JABIRU AIRCRAFT PTY LTD

SERVICE BULLETIN: JSB 020-1
Issue: 1
Date: 4th March 2008
Subject: Aileron Bellcrank Cover

Figure 1 – New Cover as Supplied

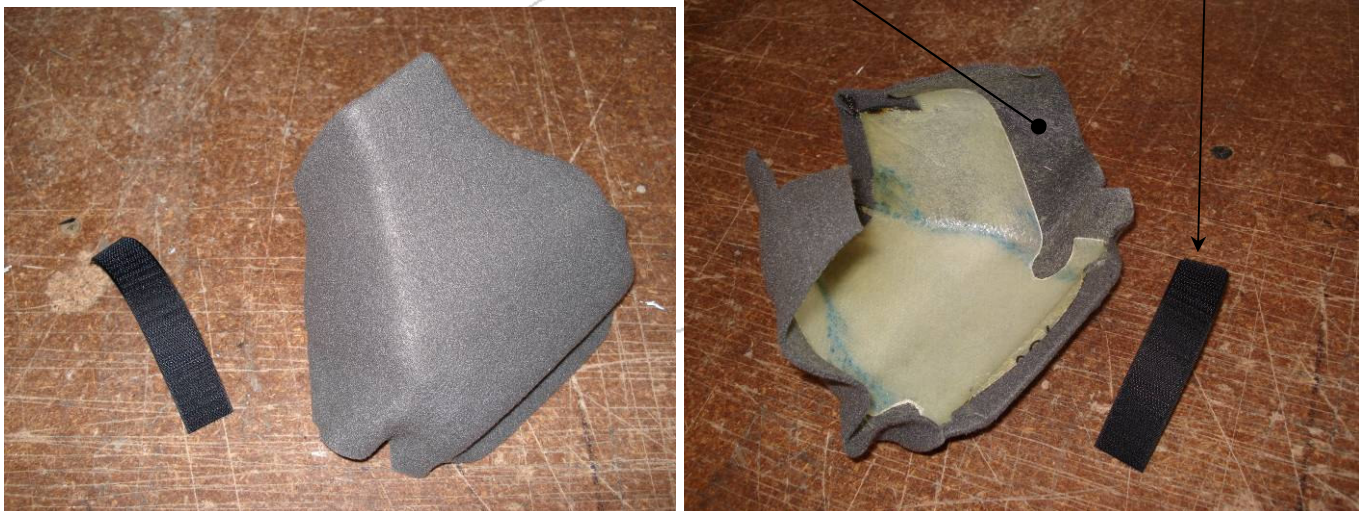
- a) Remove the existing cover
- b) Figure 1 shows the new part. Compared to the original the sides are deeper and the upholstery has been designed to overhang the part. A length of hook-side Velcro has also been supplied.

Figure 2 – New Cover Installed

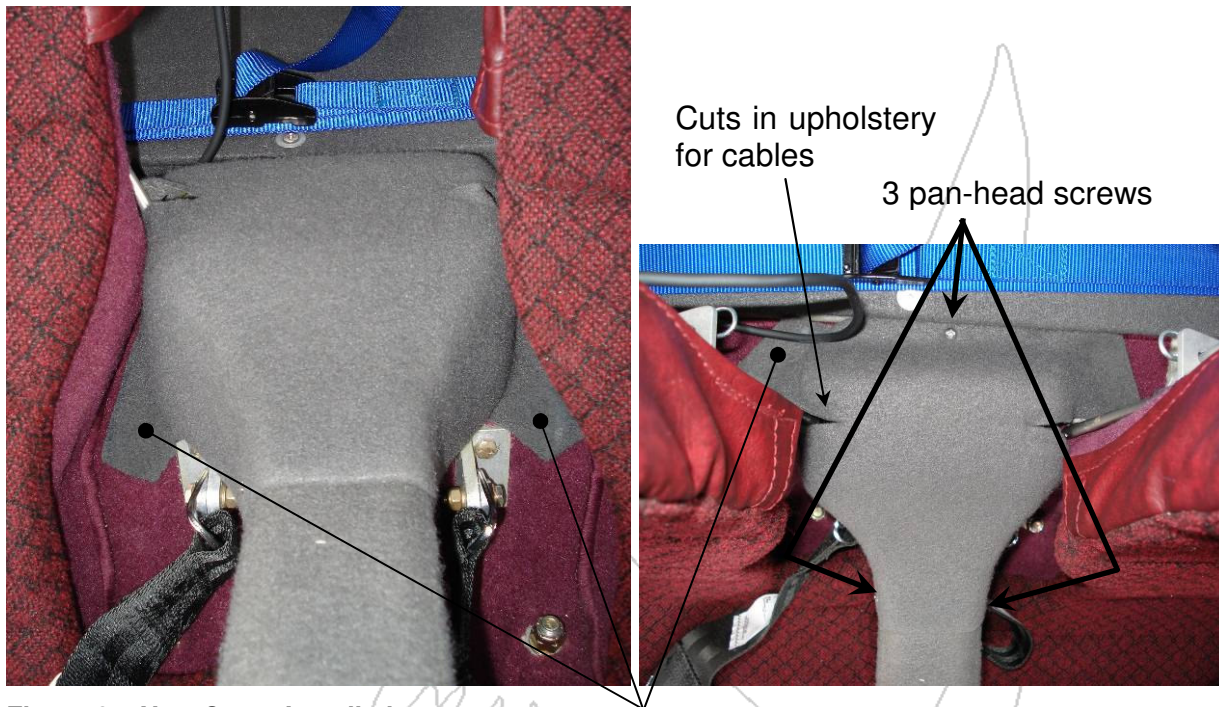
- c) Trial fit the new part. Figure 2 shows the new cover fitted to the aircraft. To fit the cover the overhanging upholstery has been trimmed back in most areas. Tabs with Velcro fitted have been left at the front and back of the part to seal the cover onto the aircraft structure. Small cuts have been made in the upholstery to allow the aileron cables to pass through.
